**ADDENDUM # 1**  
**BID # PW070024**  
**PROJECT: Capistrano Hall Re-Roof**

Date: April 11, 2008

ROOF DRAIN

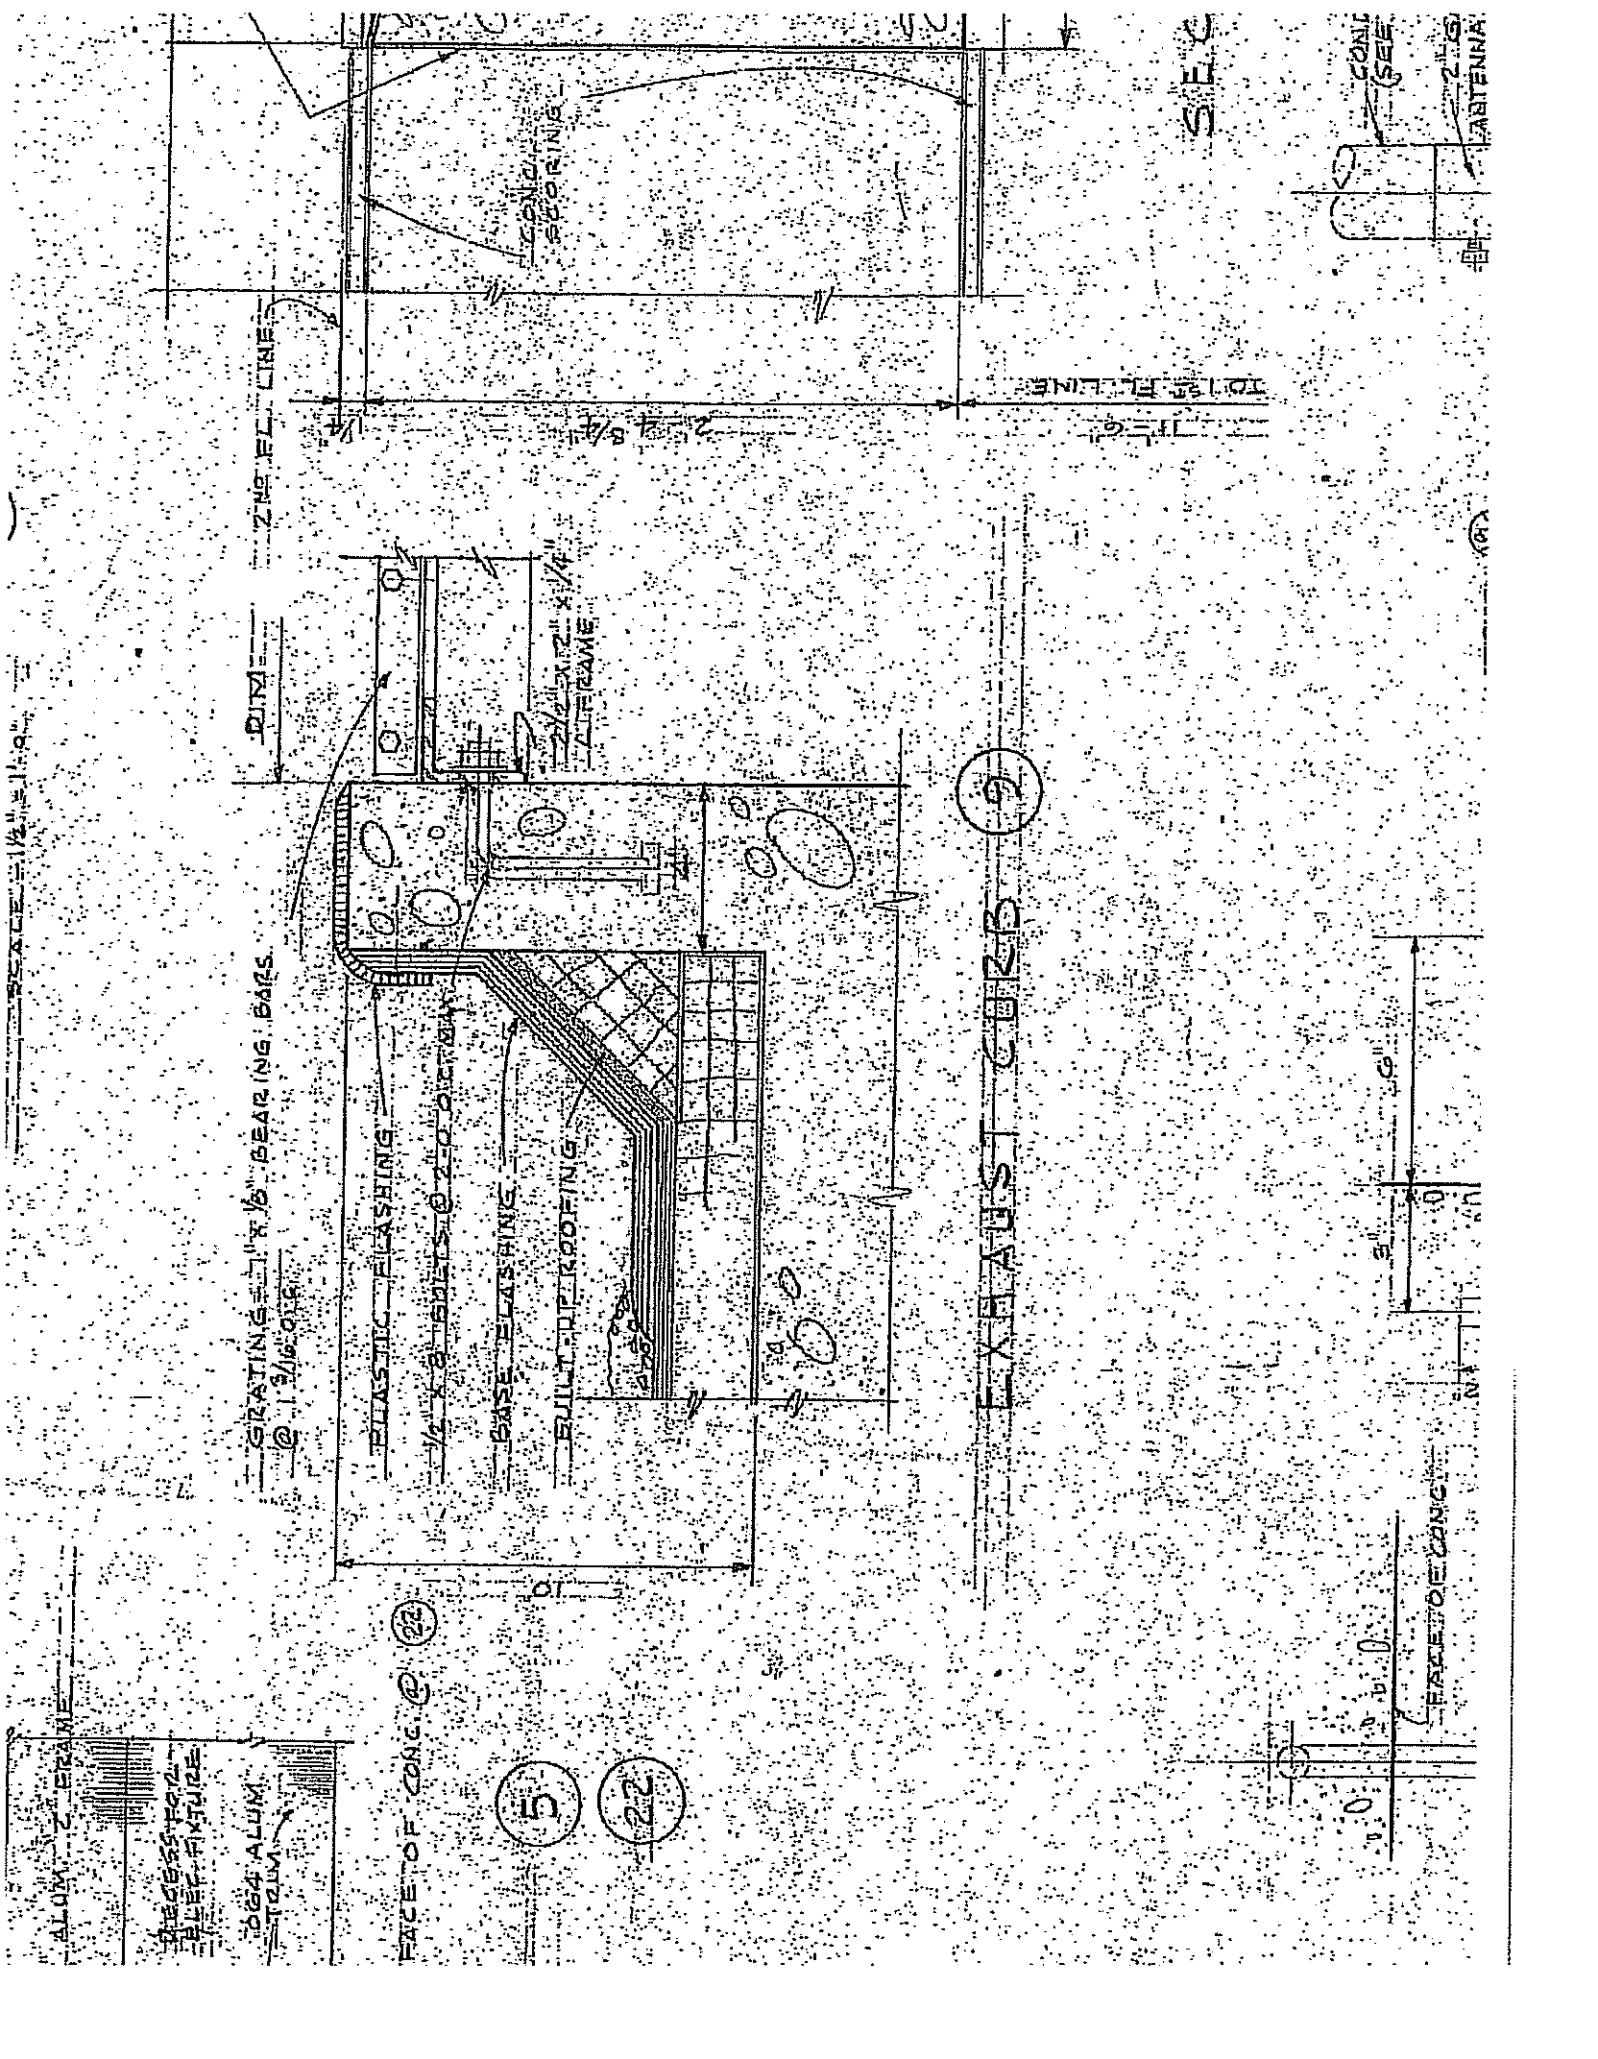
2" minimum to start the taper system due to the original Roof Drain Detail, see attached drawing.
